**DOCKET NUMBER 50-483
CALLAWAY PLANT
UNION ELECTRIC COMPANY
RESPONSE TO REQUEST FOR ADDITIONAL INFORMATION
ON REVISION TO TECHNICAL SPECIFICATION 5.5.9
"STEAM GENERATOR (SG) TUBE SURVEILLANCE PROGRAM"**

**REQUEST FOR ADDITIONAL INFORMATION
REVIEW OF THE CALLAWAY PLANT APPLICATION
FOR REVISION TO TECHNICAL SPECIFICATION 3/4.4
TAC NUMBER: MB1214**

Figure R6-1. Calibration Standard 1246536C-1: Parent Tube Region Flaws
Axial Shear Wave Detection

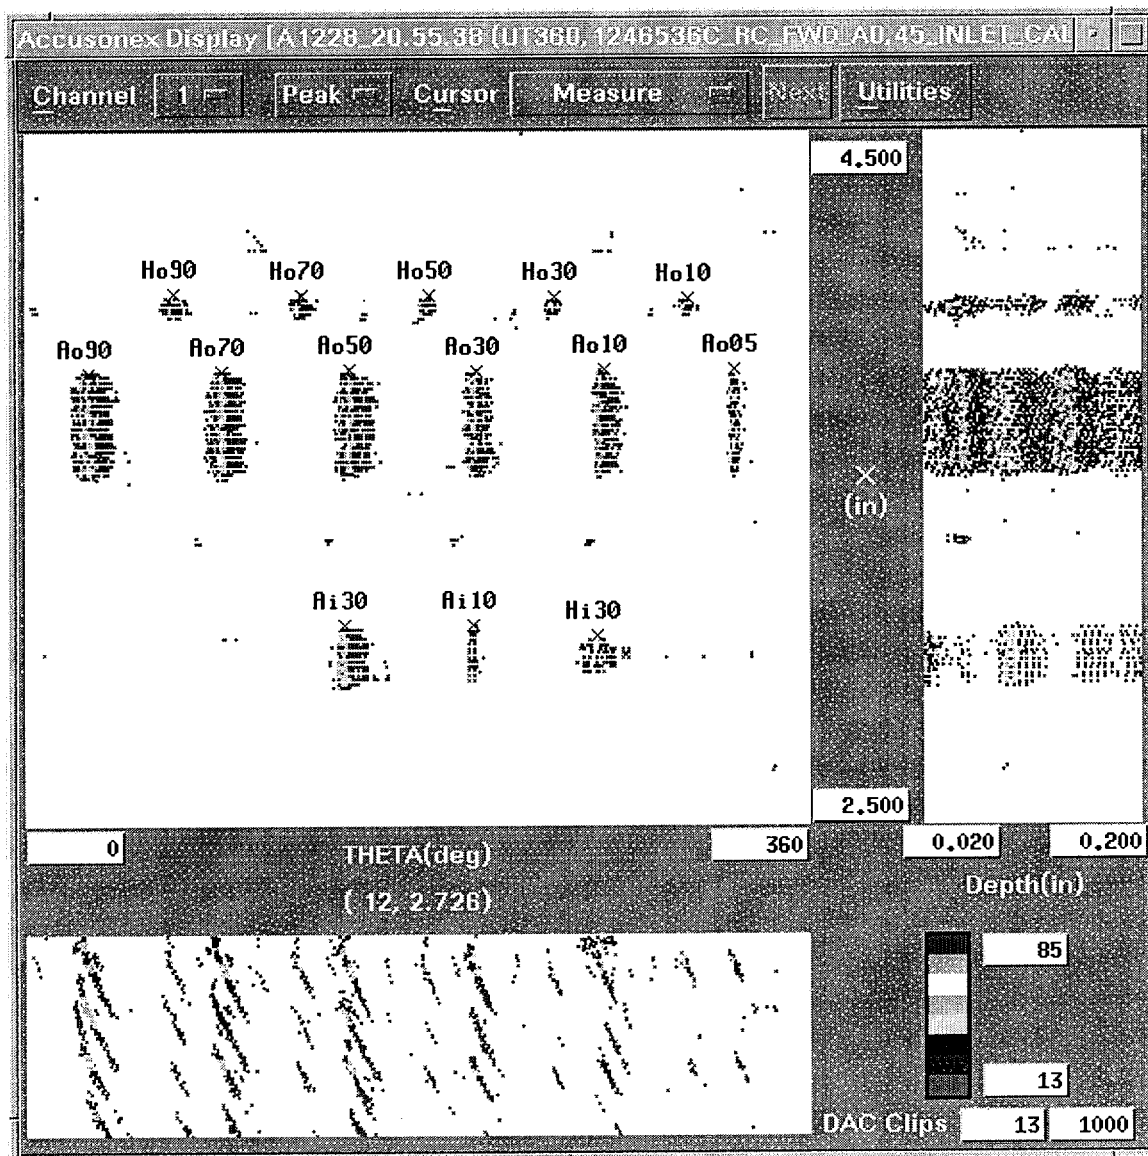
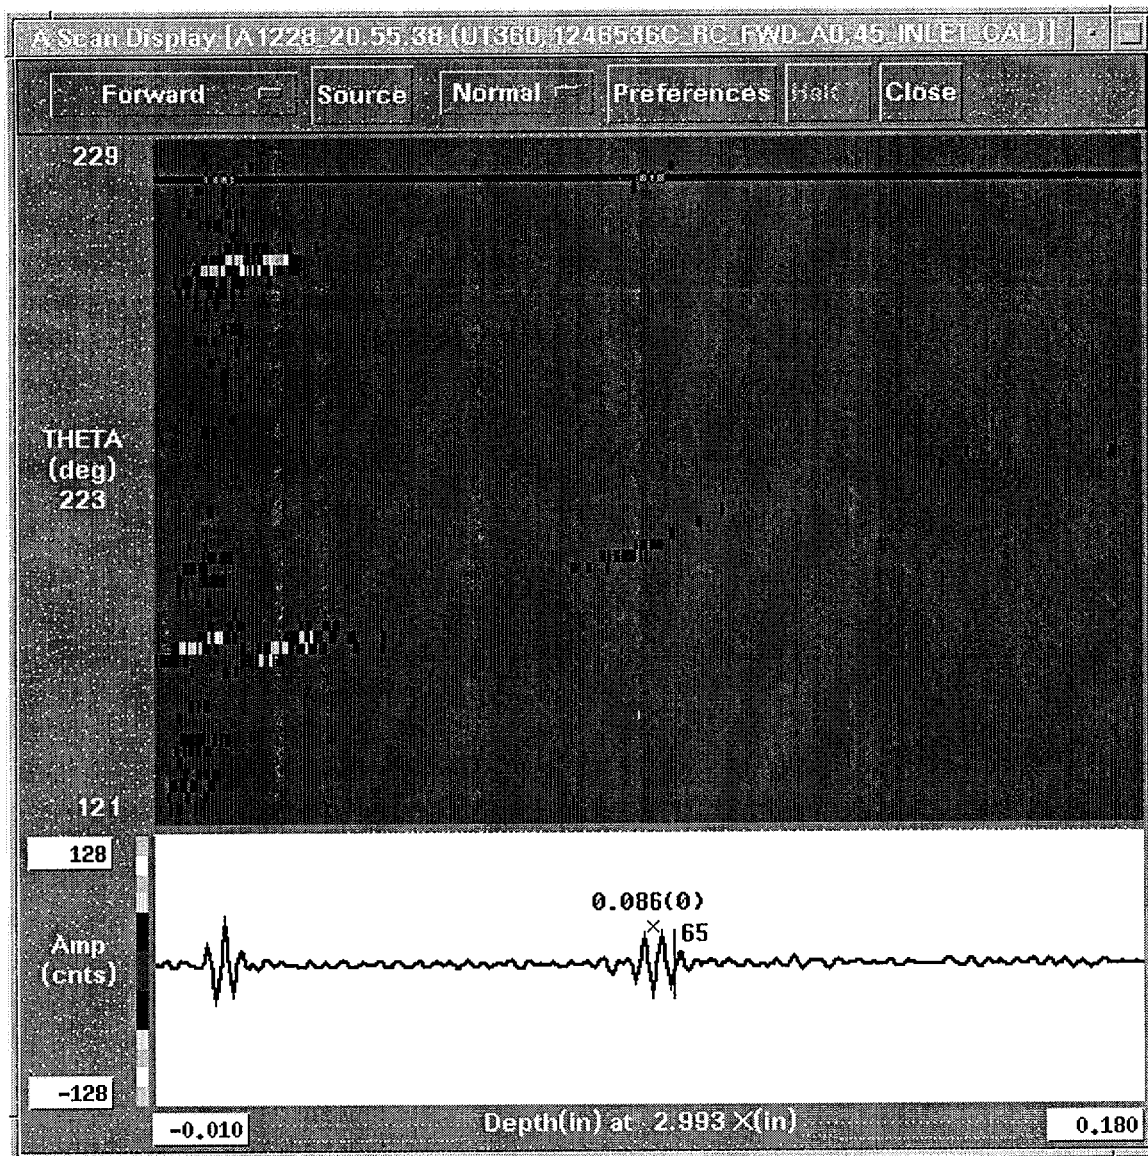
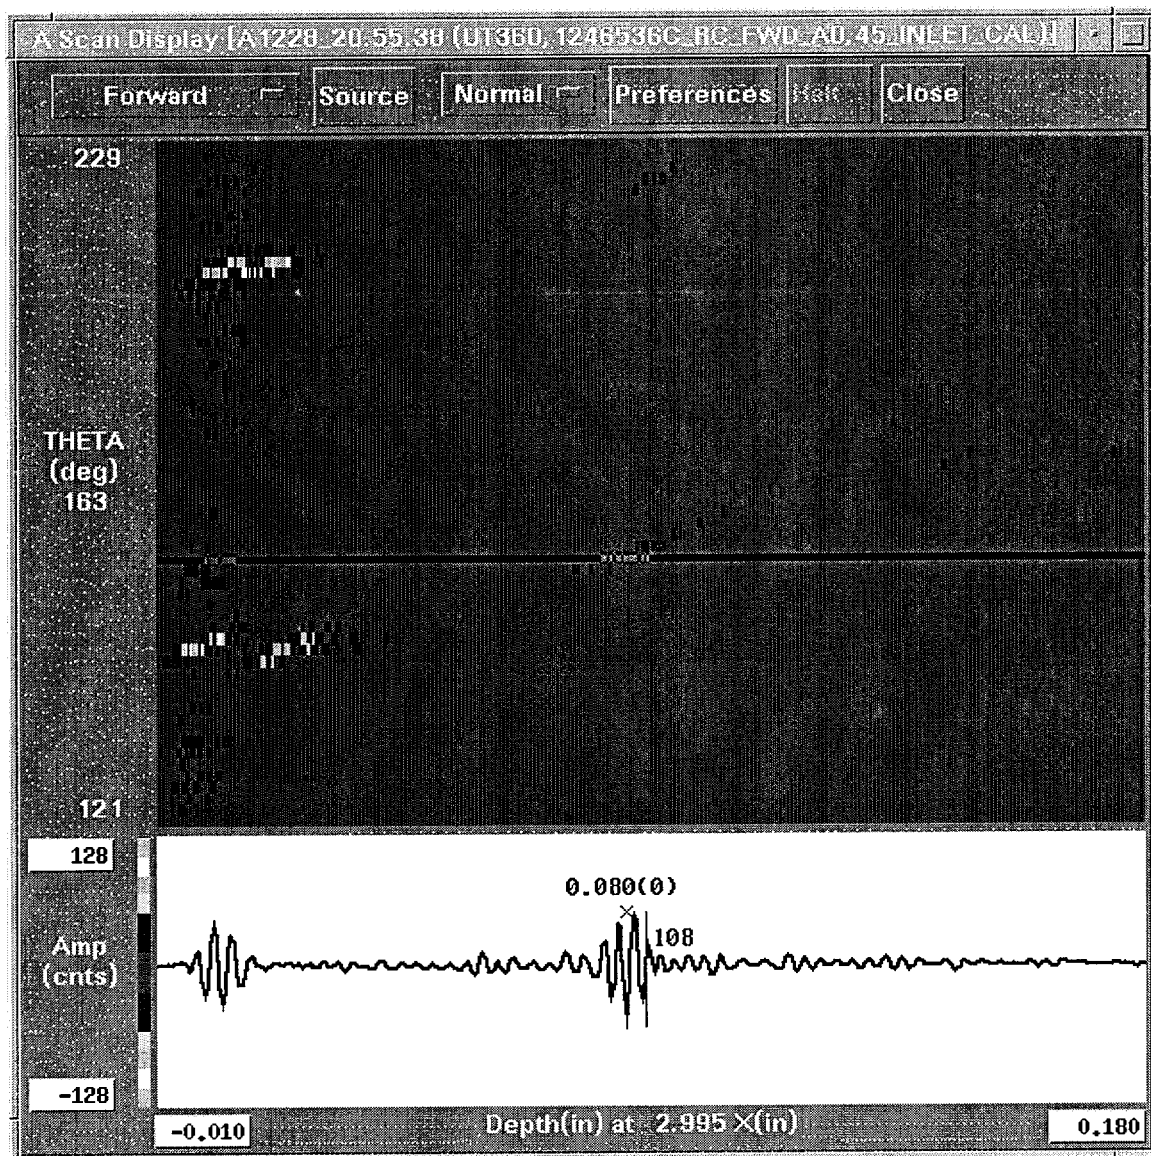
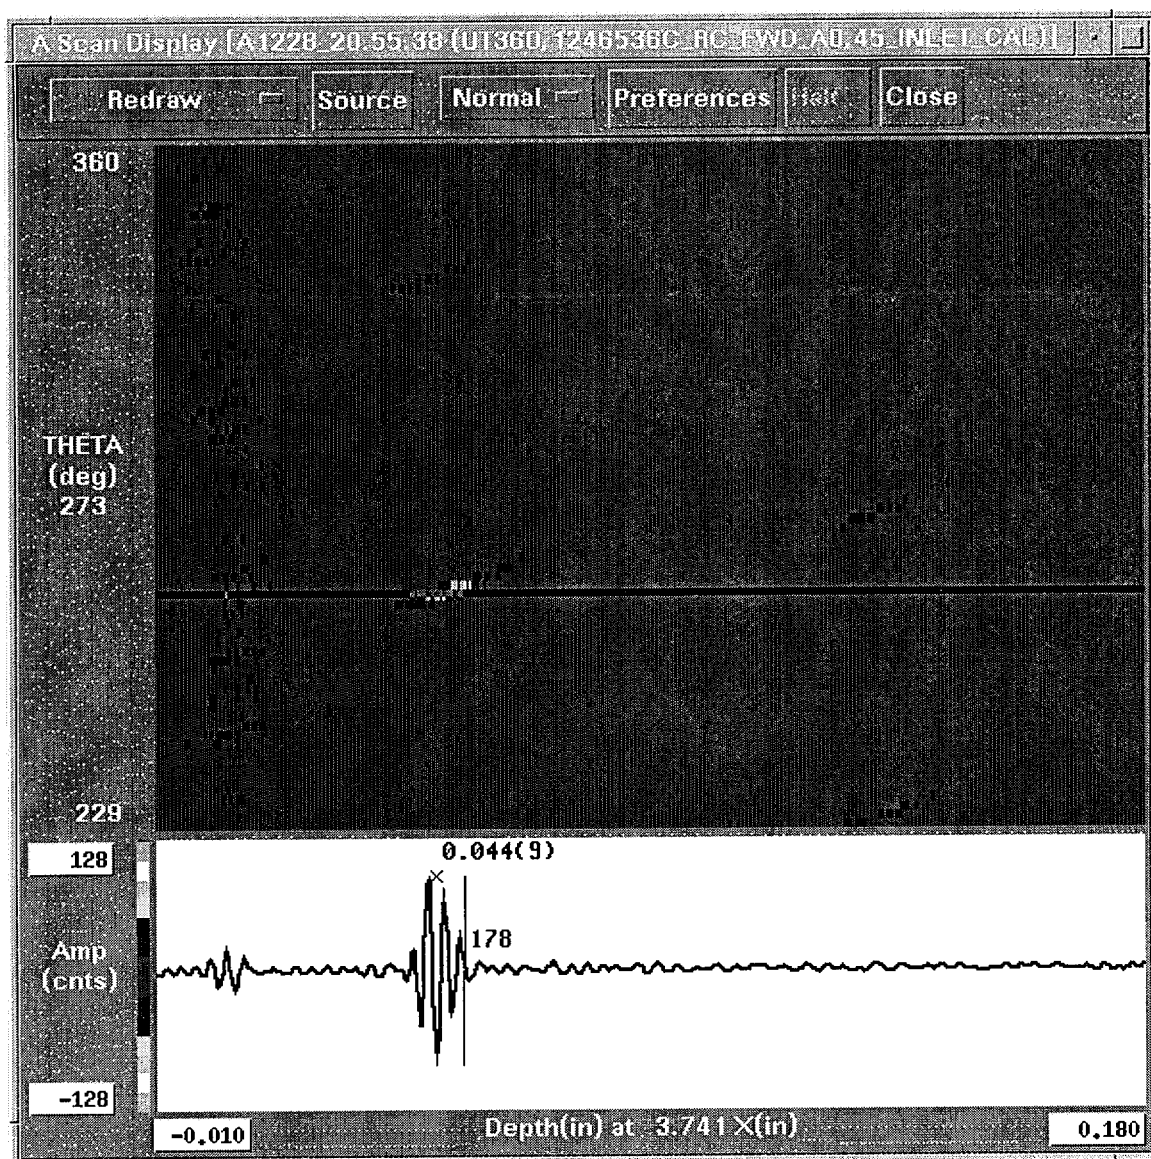
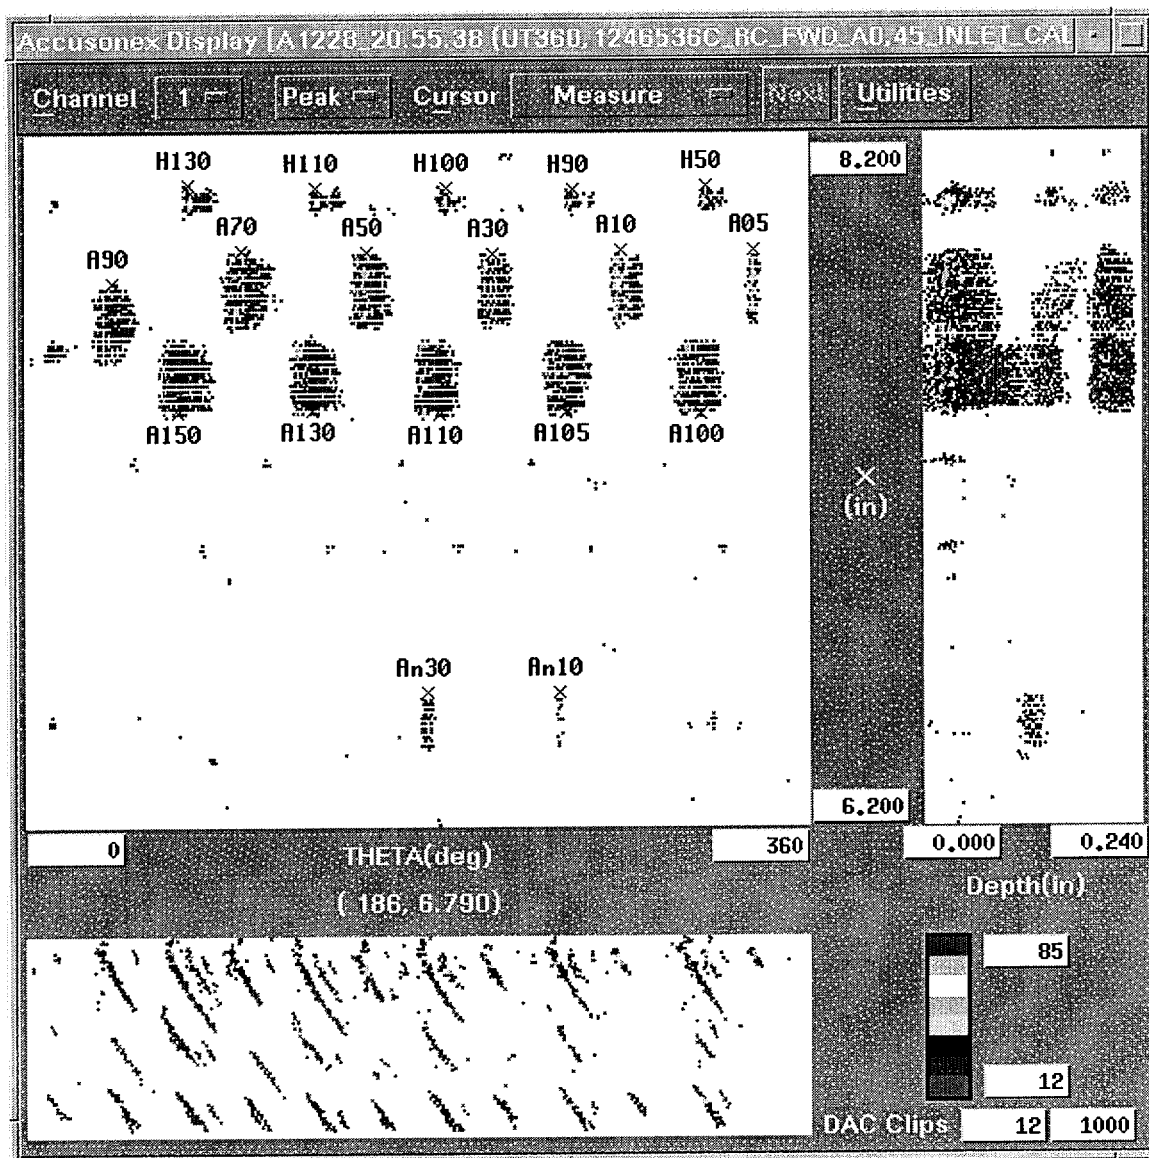
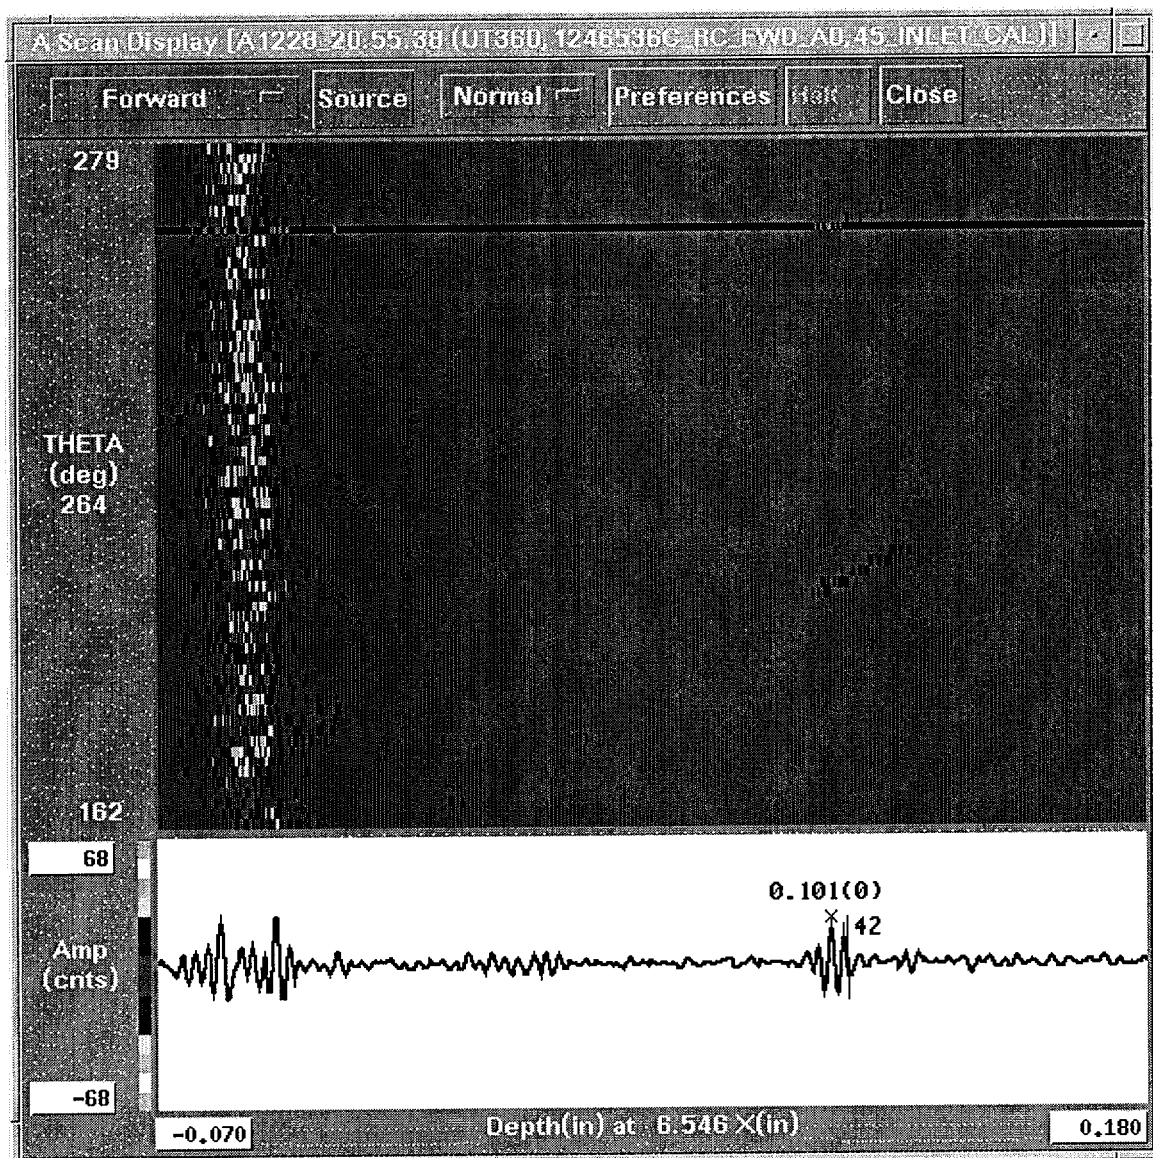
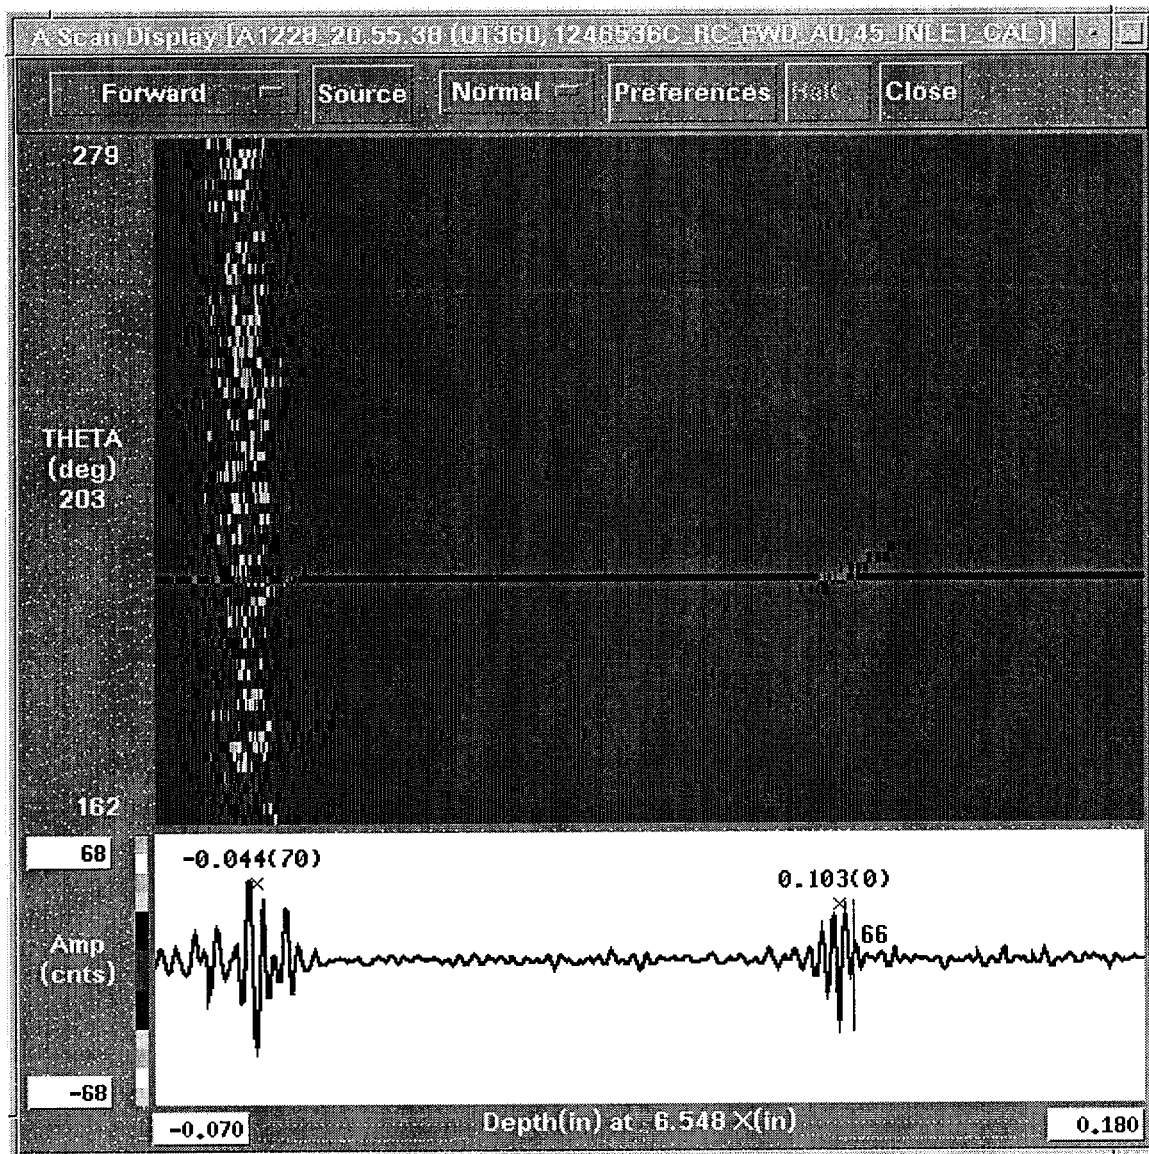
RAI # 6. During the meeting, FTI indicated that PWSCC detectability in the sleeve could be inferred from the ID notches in the UT calibration standards and the data sets containing pits. It is not clear to the staff how detecting EDM notches in the calibration standards or another degradation morphology such as pits would infer an ability to detect tight flaws such as PWSCC. Explain the basis for the statement that sleeve PWSCC ID defects will be detected, and the resulting sensitivity and POD, since the peer review (ETSS # 98404) only covers volumetric defects. Please provide additional discussion or, preferably, additional data to support the claims of the capability of the technique to detect PWSCC in the sleeve. (Question from the 6/7/01 meeting held with UE, FTI, and the NRC staff)

The assertion about the calibration standard and the inner diameter sleeve pit was to demonstrate sensitivity of the ultrasonic technique to inner diameter initiated flaws. The inner diameter pit provides a difficult cross-sectional target due to its cylindrical shape. This was felt to be a more challenging test of the detection capability of the shear wave transducers than the broad side of an EDM notch. The staff is correct in their opinion that neither of these flaws fully represent PWSCC, but these are the only morphologies available for evaluation since sleeve SCC cannot be fabricated.

To support the assertion that the system, (probe and technique) are sensitive to inner diameter flaws, three separate presentations will be offered. The first will show the sensitivity of the system to the inner diameter EDM notches in a calibration standard. The data was acquired in accordance with the

The flaws labeled "Ai" are parent tube inner diameter axial EDM notches. The flaws labeled "Ao" are parent tube outer diameter axial EDM notches. The flaws labeled with the first character "H" are EDM contoured bottom holes. Of interest is the detection of "Ai10", the 0.004 inch deep inner diameter notch.

This is the A-Scan plot showing the inner diameter corner reflection, (full skip) for the notch "Ai10". The notch is at the expected depth for the full skip, (two times the wall thickness) 0.086 inch. The peak to peak amplitude of this reflection is 65 counts out of a possible 256 counts or 25% full screen height.

This is the A-Scan plot showing the inner diameter corner reflection, (full skip) for the notch "Ai30". The peak to peak amplitude of this reflection is 108 counts or 42% full screen height.

This is the axial EDM notch that is used to establish the sensitivity and time-of-flight to depth calibration. The sensitivity must be set between 50% and 80% of the digitizer full scale. For an eight bit digitizer, the full scale is 256 counts (cnts). The amplitude of this reflection is 178 counts or (178/256), 70%.
